Preliminary Information

PIP5411F SES light with DTC's P2635 and/or P018B setting in high ambient temperatures

Product Investigation Review Required

New design

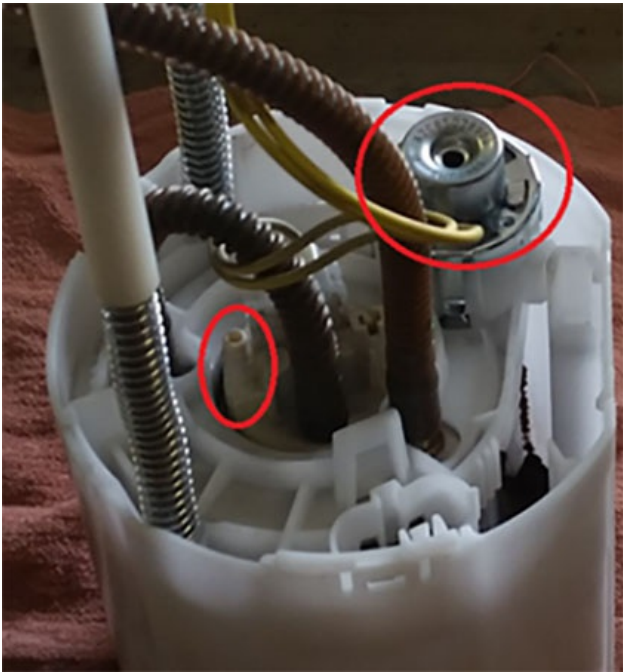
This PI should only be followed if SI diagnostics have been performed with no solution found.
Replace the in tank fuel pump module assembly with the new design part.

This is a temporary fix and Engineering is working on a permanent repair.

Important: If a new design fuel pump has already been installed and is currently meeting diagnostic pressure specifications, do not install another new design fuel pump in an effort to resolve the condition.
